Town of Breckenridge
Planning Commission Agenda
Tuesday, May 4, 2010
Breckenridge Council Chambers
150 Ski Hill Road

PLANNING COMMISSION MEETING

Project Name/PC#: Froehlich-Olmsted Residence PC#2010022
Project Manager: Julia Puester, AICP
Date of Report: April 27, 2010 for meeting of May 4, 2010
Applicant/Owner: Kathleen Froehlich and Thomas Olmsted
Agent: Michael Shult
Proposed Use: Single Family Residence
Address: 714 Highlands Drive
Legal Description: Lot 147, Filing 6, Highlands Subdivision
Site Area: 51,918 sq. ft. 1.19 acres
Land Use District (2A/2R):
 LUD 6: Subject to the Delaware Flats Master Plan
Existing Site Conditions: The site is up sloping. There is a moderately steep drainage swale at the north end of the property. There are some significant lodgepole trees on site.

Project Name/PC#:	Carter Park Overlook	PC#2010024
Project Manager:	Matt Thompson, AICP	
Date of Report:	April 28, 2010	For the 05/04/2010 Planning Commission Meeting
Applicant/Owner:	Double Diamond Property and Construction	
Agent:	Michael Gallagher	
Proposed Use:	Single family residence	
Address:	50 Carter Drive	
Legal Description:	Lot 30 Sunbeam Estates	
Site Area:	18,413 sq. ft.	0.42 acres
Land Use

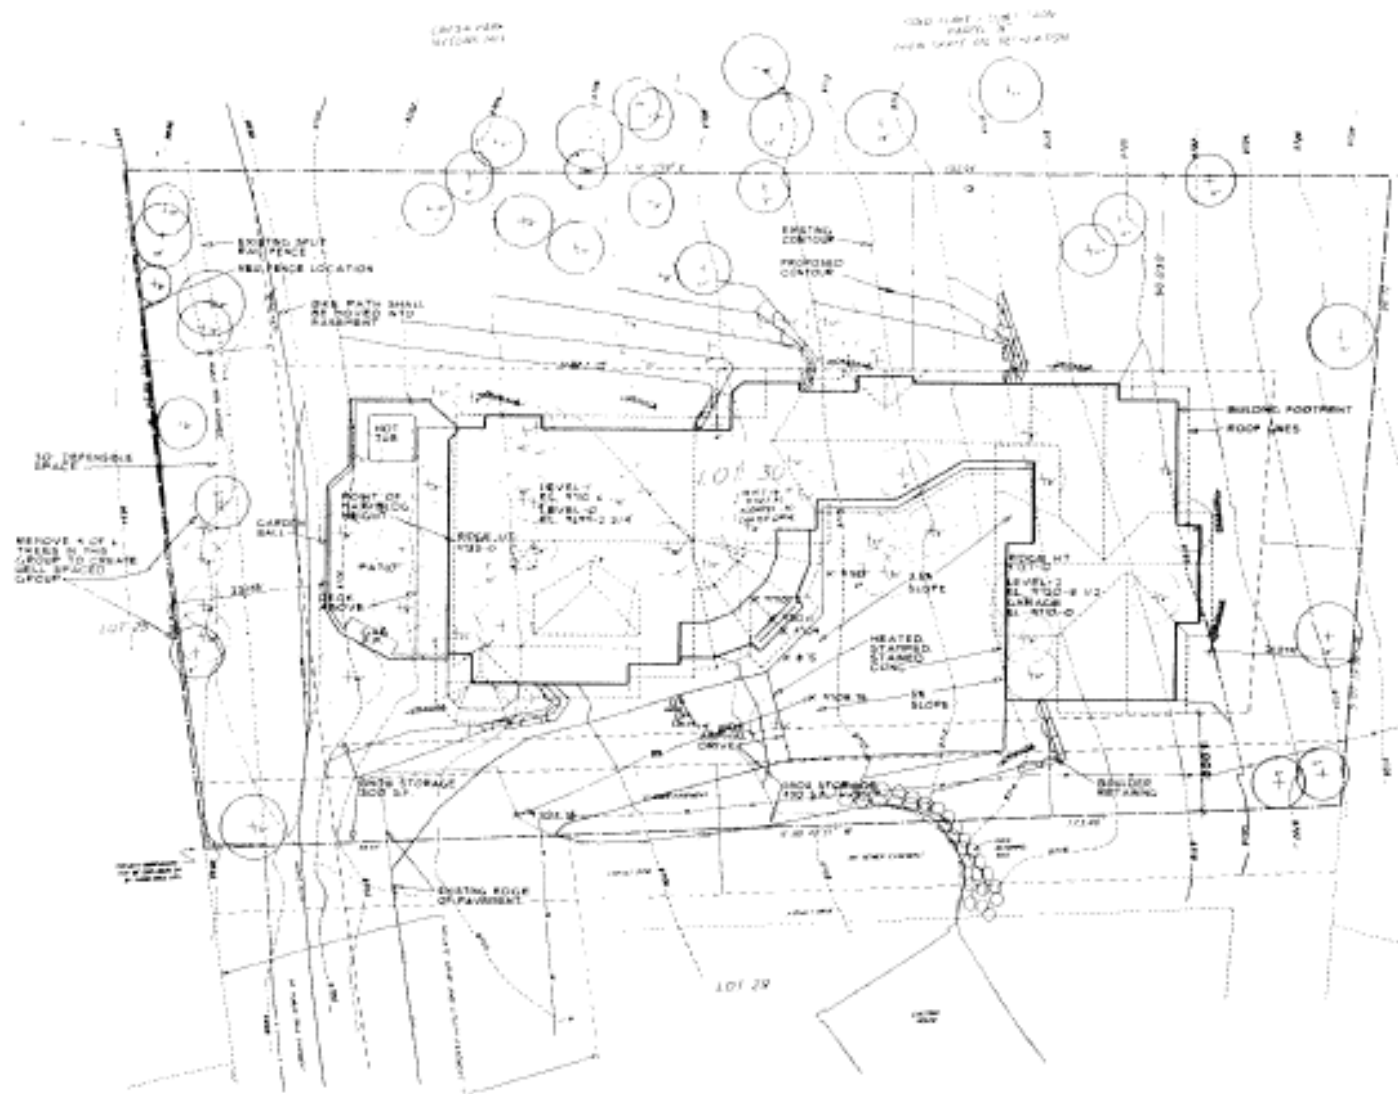
10. The snowmelt system/heated driveway/heated patio shown on the site plan reviewed by the Planning Commission are not approved at this time. If the Applicant wishes to install a snowmelt system/heated driveway/heated patio in the future on this property, a separate development permit will be required.

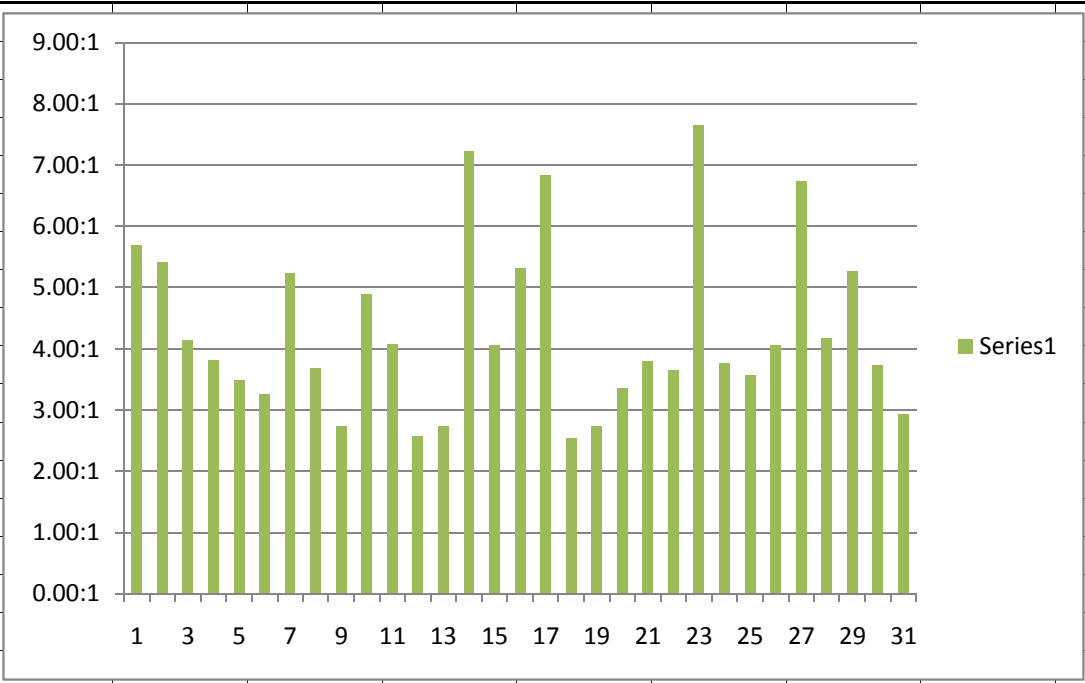
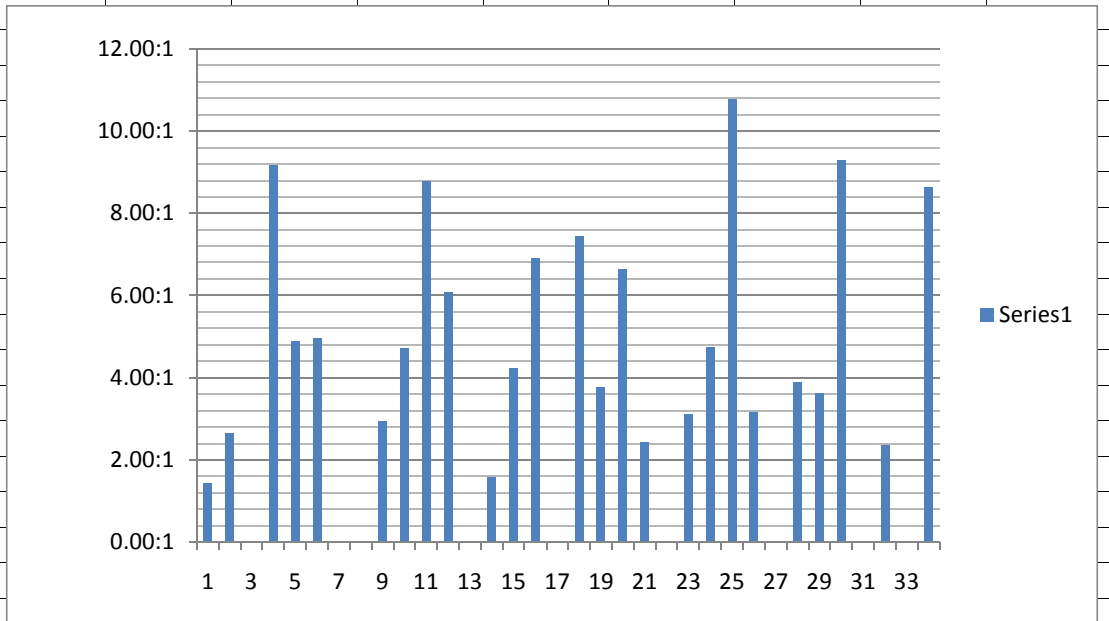
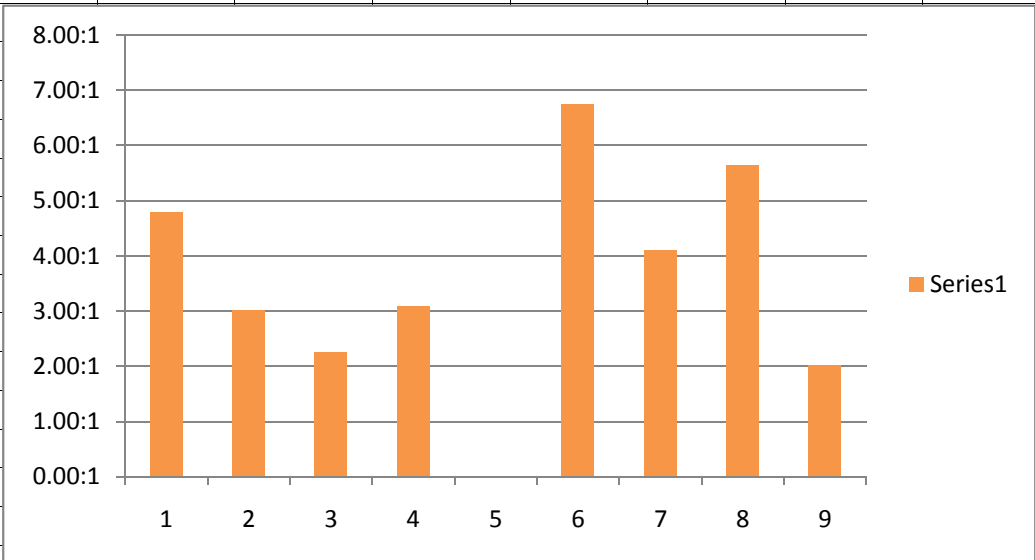
Staff has questions regarding this discussion:

1. Does the Commission support adding language to Policy 274 identifying window forms to be rectangular and placed in groupings no greater than three?
2. Does the Commission believe that a solid to void ratio should be specifically identified under Policy 274? (For example 3:1, or not greater than 2:1)
3. We welcome any additional comments.
